NL-17-142

**SUBJECT:** Response to Request for Additional Information Regarding Request IP2-  
ISI-RR-20 for Relief from Examinations of Code Class 1 Component  
Welds with Less Than Essentially 100% Coverage for Fourth Ten-Year  
Inservice Inspection Interval Closeout  
Indian Point Nuclear Generating Unit No. 2  
Docket No. 50-247  
License No. DPR-26

REPLY TO NRC REQUEST FOR ADDITIONAL INFORMATION  
REGARDING RELIEF REQUEST IP2-ISI-RR-20

Figure 1  
Weld 351 2 – Elbow to Boss/Nozzle

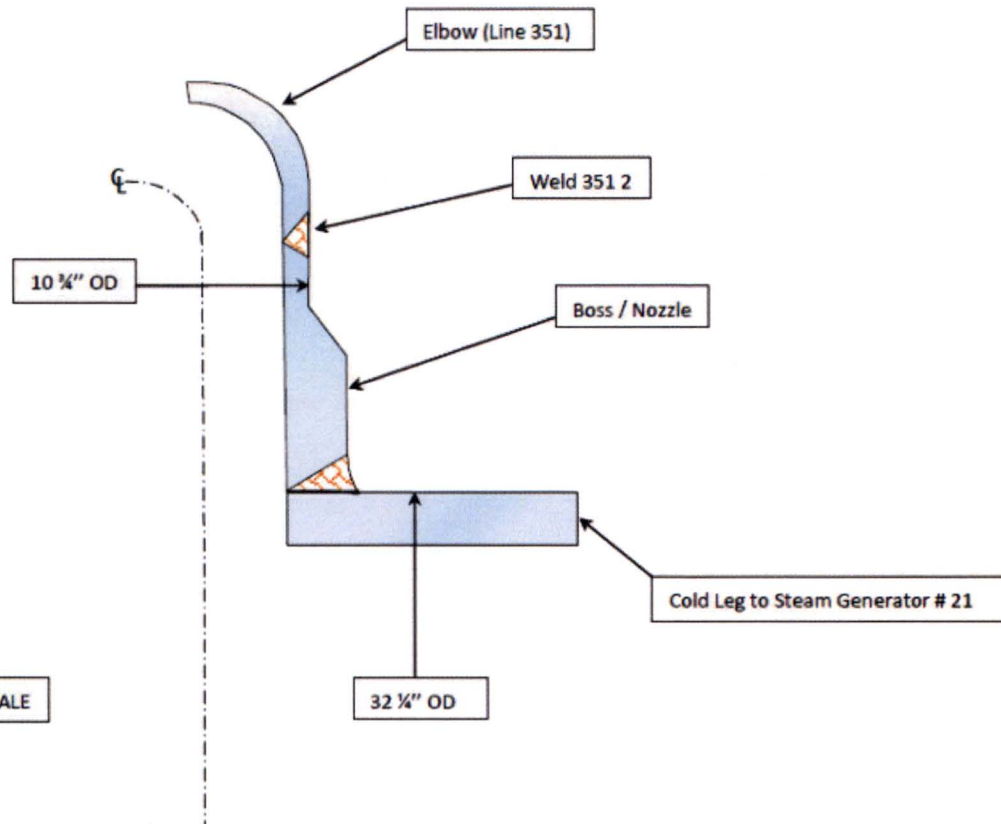
1. In the submittal, the licensee described Weld No. 351 2 as an elbow to sweep-o-let to pipe weld in one sentence and as a branch connection sweep-o-let to pipe weld in another. The NRC staff has difficulty determining type/location of this weld from the descriptions provided.

(e.g., Does Weld No. 351 2 joint a sweep-o-let to a pipe to create a branch connection on a pipe? Does Weld No. 351 2 joint a sweep-o-let to an elbow to create a branch connection on an elbow? Does Weld No. 351 2 joint an elbow to a sweep-to-let?).

Provide clear descriptions, type, and/or location of this weld, and if possible, supplement with sketches and/or photographs.

Weld 351 2 is a Class 1 weld, which attaches a 10" boss/nozzle to a 10" elbow. See Figure 1 in Attachment 2 for additional details.

Weld 351 2 is a Stainless Steel (SS) weld which joins a 10" SS A-403 WP-316 elbow to a SS A-182 F-316 Boss/Nozzle.

Figure 2  
Drawing D207909-0 / Weld RCC21-14  
(Typical for Welds RCC21-14, RCC22-14, RCC23-14 & RCC-24-14)

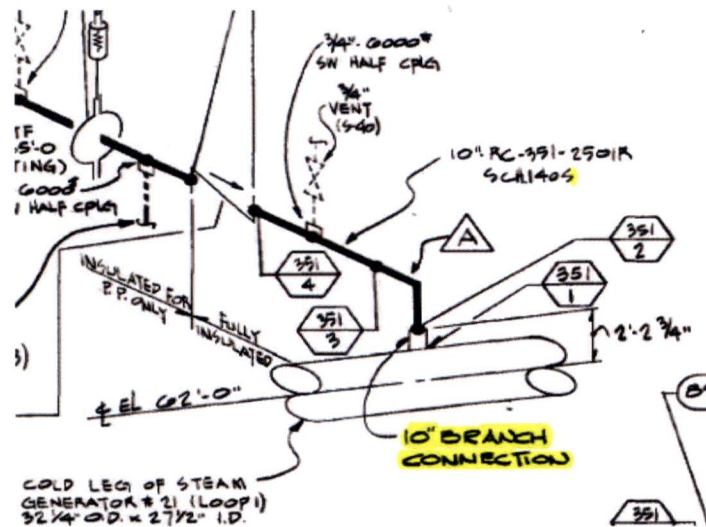
- a. Discuss in detail which components (weld, elbow, safe end, and/or nozzle) of Weld Nos. RCC21-14, RCC22-14, RCC23-14, and RCC24-14 were clad. If possible, supplement with a sketch showing that sound waves travel through clad into components (weld, elbow, safe end, and/or nozzle).

Each of these four (4) welds are of similar construction and have a stainless steel overlay covering the inside diameter surface of the safe-end and pipe groove weld. This overlay is the "clad" being referred to at the bottom of page 8 of 10 in attachment 1 to the relief request IP2-ISI-RR-20 (Reference 1). Refer to Attachment 2, Figure 2.
